**RE: Removal Action Work Plan (RAWP)
Former WPSC Green Bay Manufactured Gas Plant Site, Green Bay, Wisconsin
Wisconsin Public Service Corporation
CERCLA Docket No. V-W-06-C-847, CERCLIS ID – WIN000509948, BRRTS # - 02 05
000254**

Wisconsin Public Service Corporation (WPSC) is submitting the attached Addendum No. 1, Revision 0 to the Early Removal Action (ERA) Work Plan - Revision 2 for the Green Bay Former Manufactured Gas Plant (MGP) Site, Wisconsin Public Service Corporation (WPSC), Green Bay, Wisconsin.

To: Frank Dombrowski and Glenn Luke - WPSC
From: Abby Small and Julie Zimdars – Ramboll
cc: Staci Goetz - Ramboll
Re: Early Removal Action Work Plan Addendum No. 1, Revision 0
 Green Bay Former Manufactured Gas Plant, Green Bay, Wisconsin
 Wisconsin Public Service Corporation
 CERCLA Docket No. V-W-06-C-847, WDNR BRRTS # 02-05-000254,
 CERCLIS ID – WIN000509948

ATTACHMENT B – UPDATED SHEETS C-090 AND C-100

UPDATED FIGURE 6 - PROPOSED POST-EXCAVATION SAMPLING PLAN

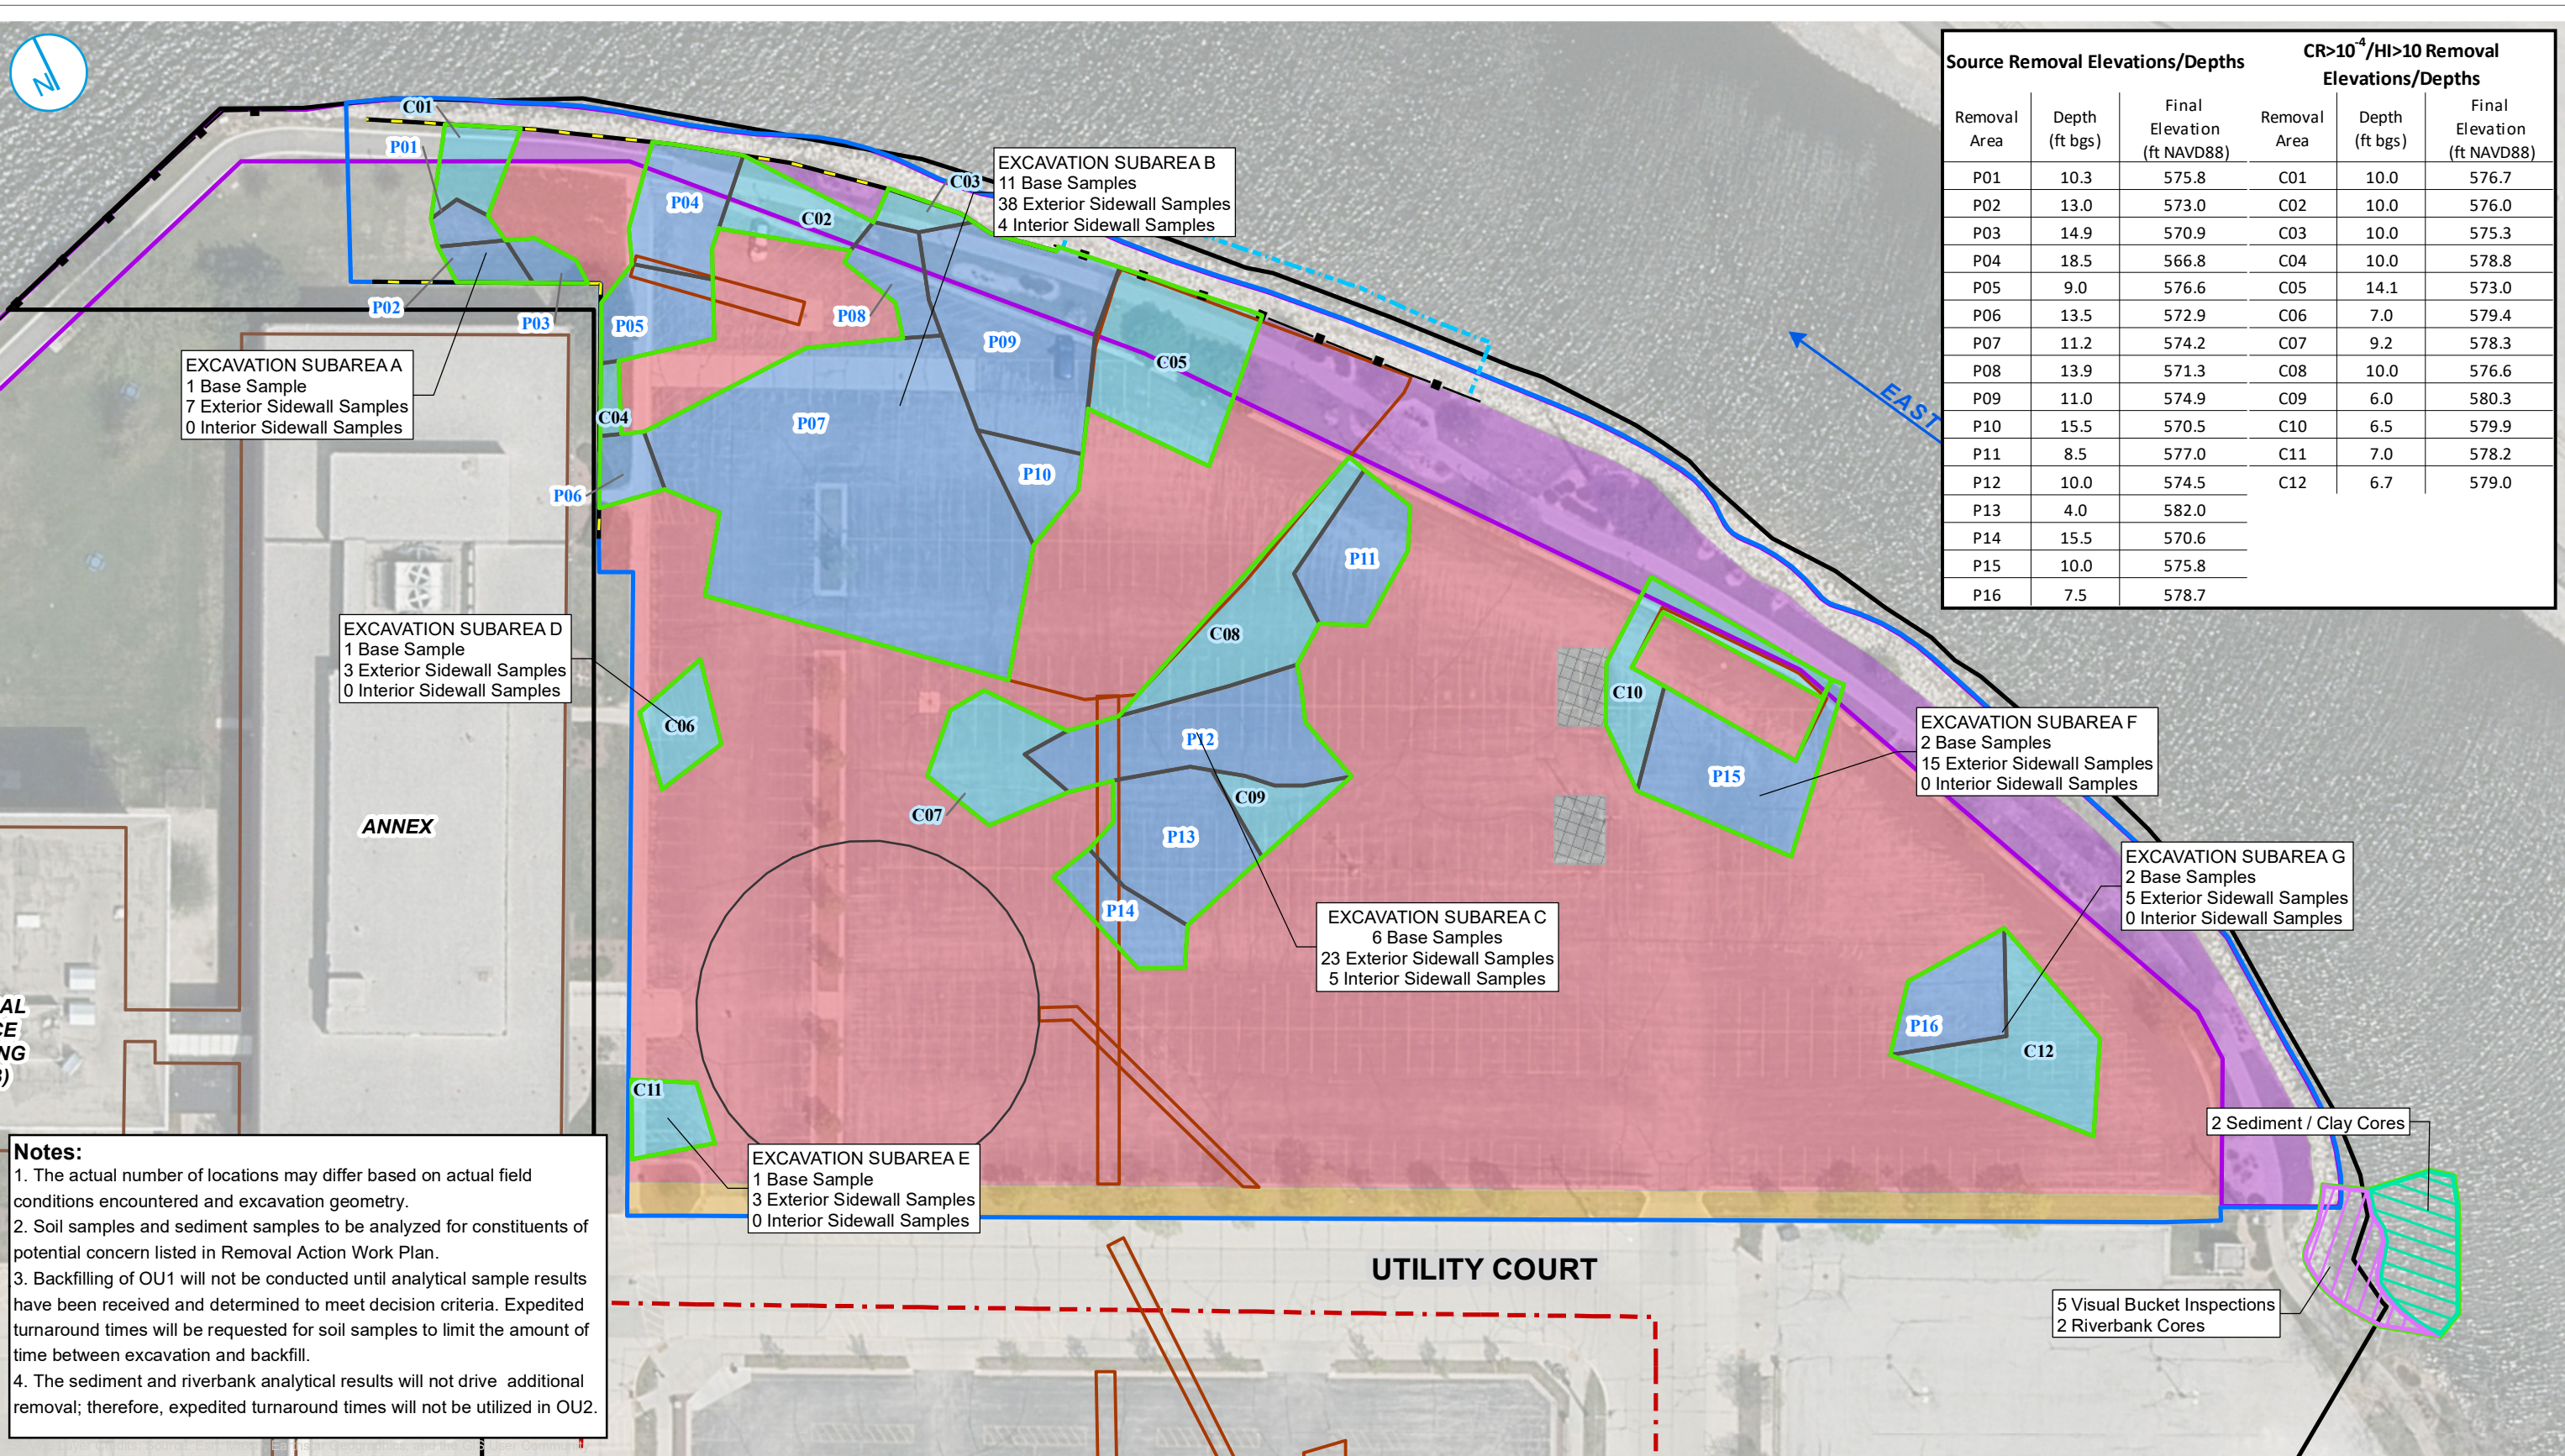
Figure 6 (Proposed Post-Excavation Sampling Plan) from the ERA Work Plan has been updated to include the proposed visual bucket inspection locations.

C-090

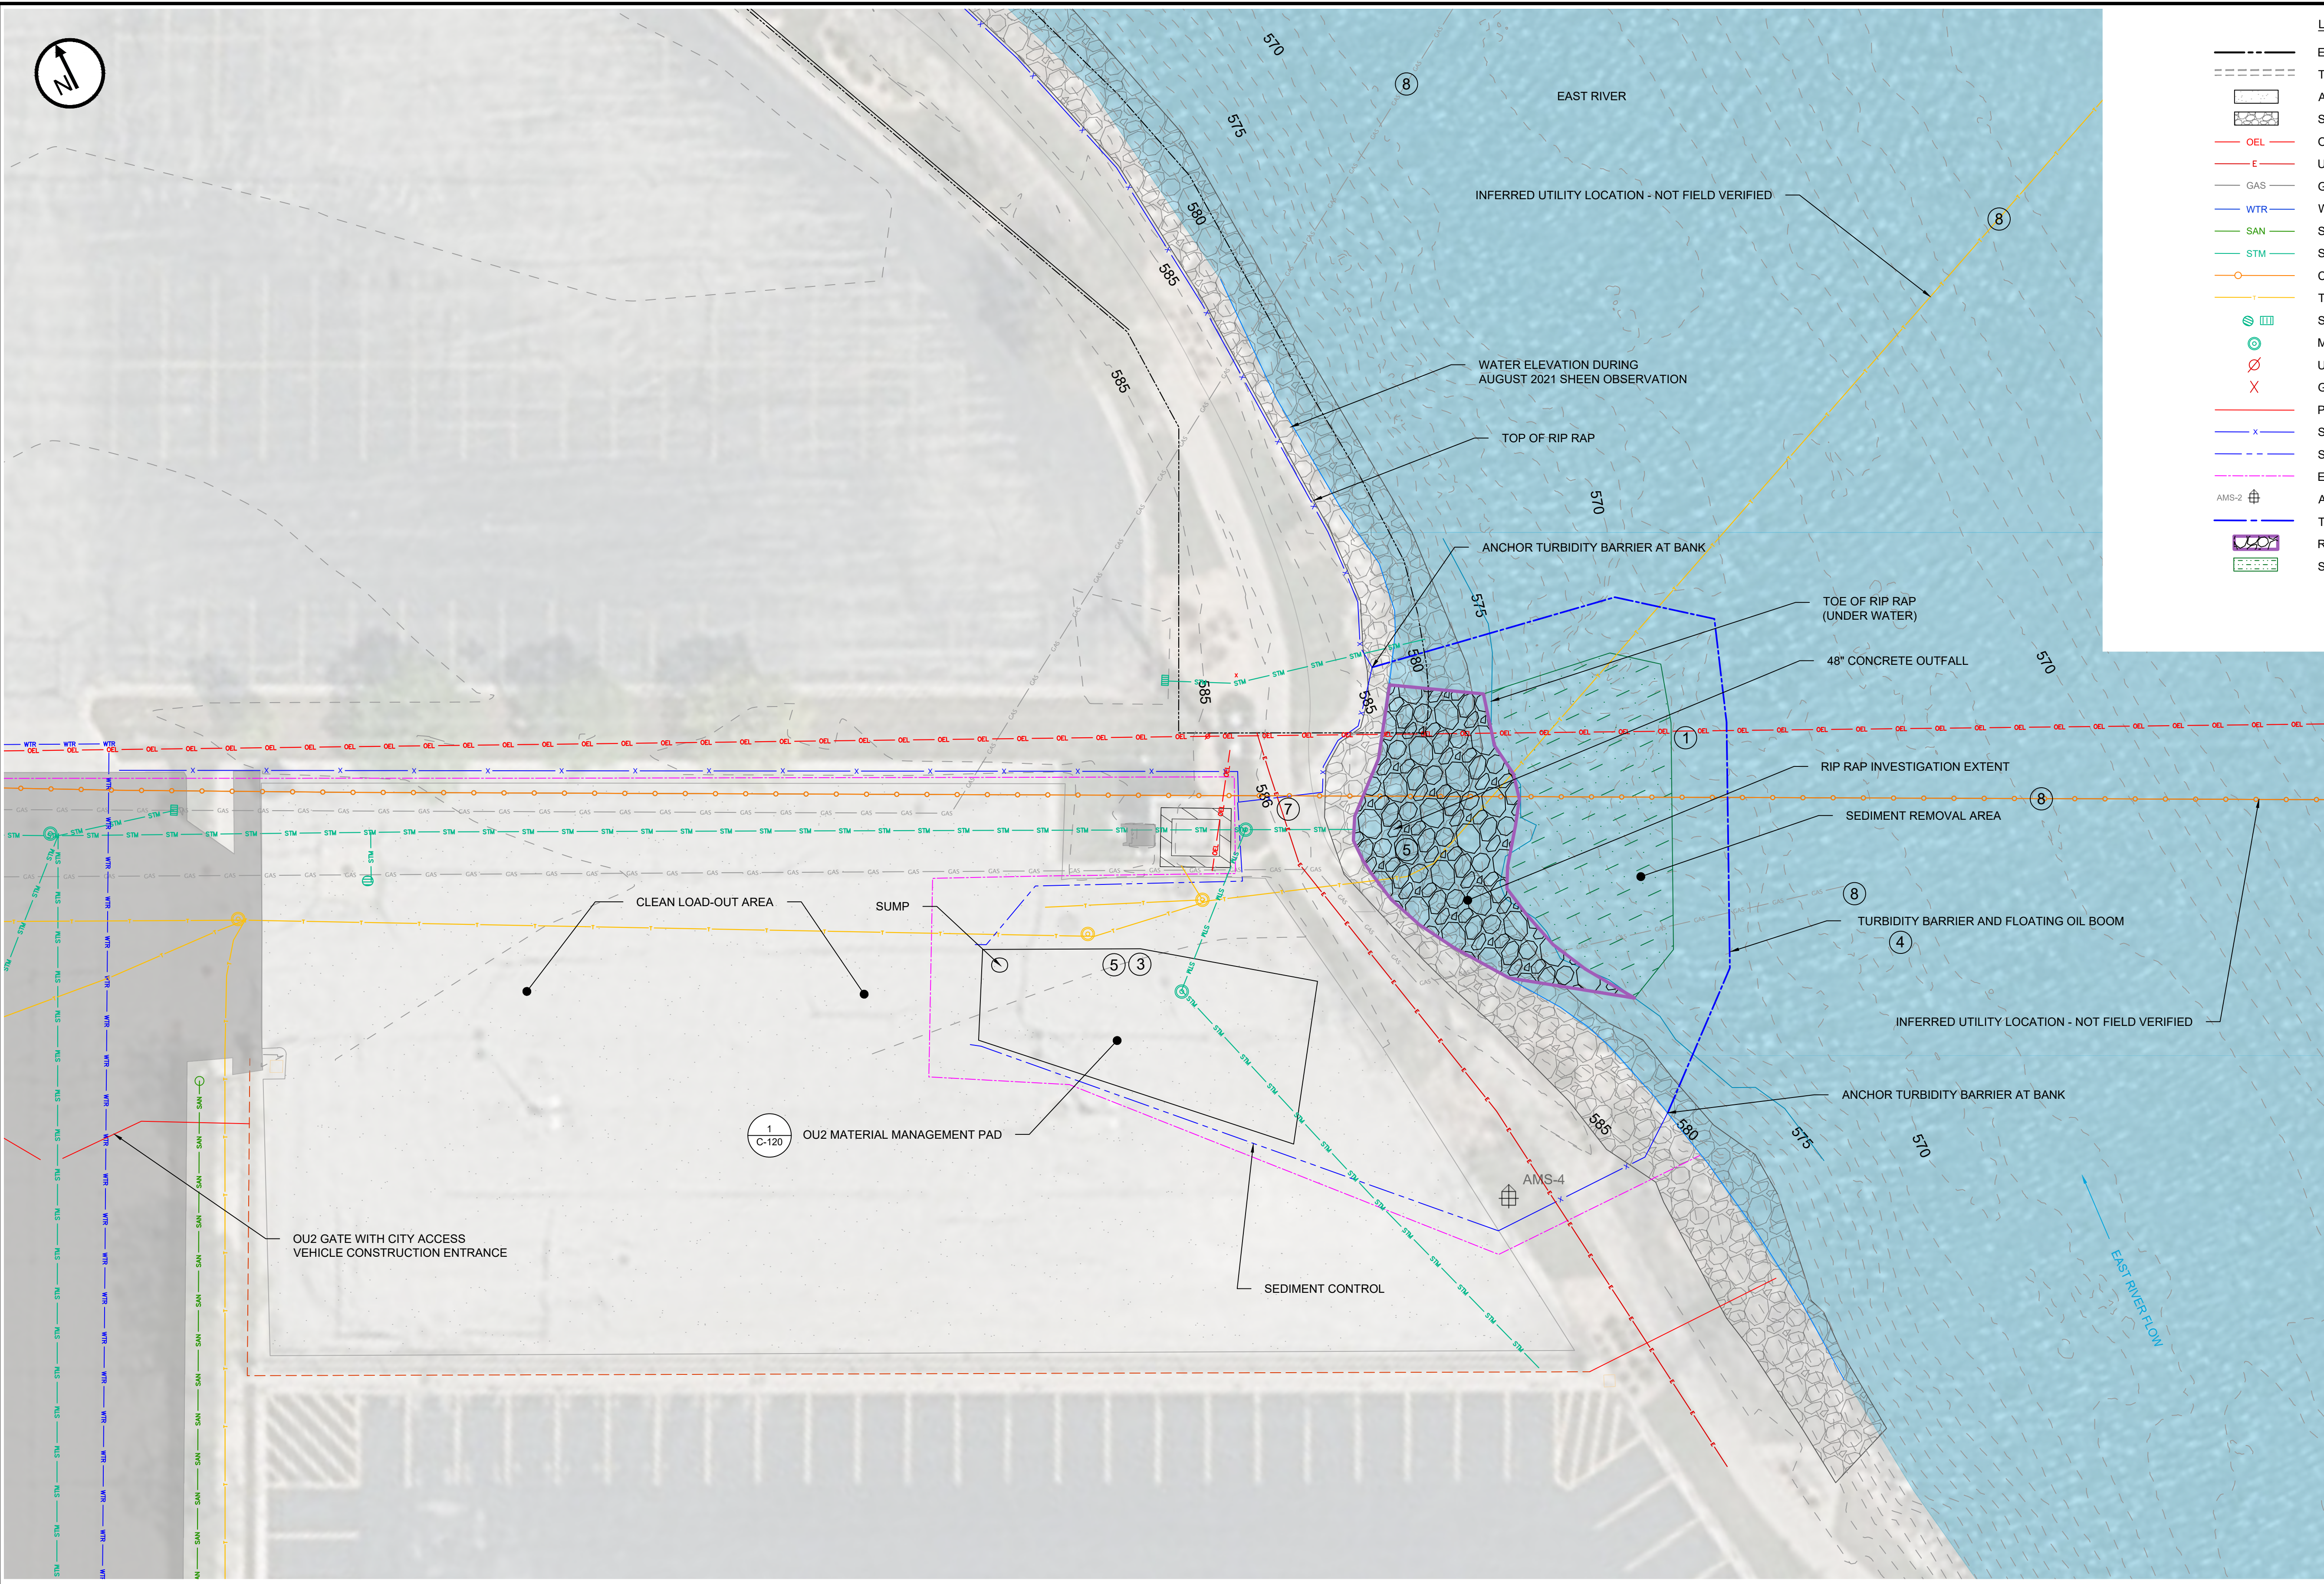
- An additional active telephone line was identified crossing the proposed removal area (Sheet C-090) along with the previously identified active communication line and abandoned gas line. As determined previously, the presence of these utilities precludes the use of sheet pile in the removal area and is not considered feasible.

As an initial step, a turbidity barrier with floating adsorbent boom will be installed to contain any turbidity during construction activities as shown on Sheet C-090. The barrier system will be 200 feet long and extend to bottom of riverbed (likely maximum 13 feet deep) with low permeability fabric, equipped with foam floatation logs, ballast chains, and associated hardware. The barrier will be connected to concrete jersey barriers located on the riverbank at both ends of the containment. In the river, the barrier will be held in place with a series of anchor systems connected every 50 feet and at critical corners. Anchor systems will include 50 lb. Danforth anchors, ballast chains, shock lines and buoys. Inside the barrier, the remedial contractor will also deploy and maintain sorbent boom to contain any potential sheen and/or collect any potential floating non-aqueous phase liquid (NAPL). The remedial contractor will have additional barrier and sorbent boom available on-site in the event the primary barrier is damaged, or that a secondary barrier is needed based on the Water Quality Monitoring Plan provided in Section 5.7 of the ERA Work Plan. The barrier will not be keyed into the riverbank as it is unnecessarily intrusive and would require removal of rip-rap and sediment in areas beyond the remedial limits, creating turbidity during installation and removal with no significant improvement of the barrier performance. Steel posts will also not be used due to the presence of utilities.

As part of the site setup, the Sediment Material Management Pad (MMP) will be placed closer to the work area such that the excavator(s) can place impacted material directly onto the pad in the approximate location shown on Sheet C-090. A plastic liner will be placed on the ground between the MMP and the work area to contain any potential spillage.

4. Install turbidity barrier, per DNR technical standard 1069, using floatation logs, anchors every 50 feet and at corner, buoys and ballast chains as required due to utilities present, and attach floating oil adsorbent boom in river for sediment controls in river prior to any disturbance. Anchor each end of barrier at riverbank with concrete jersey barrier.

5. Remove rip rap in designated area and transport to material management pad for decontamination using mechanical removal and pressure washing. Engineer to approve prior to re-use.

6. OU2 removal area is not in the Federal Navigation Channel.
 7. Provide for Engineer review, a diversion plan to divert storm water from the City lift station to river outside the containment area.
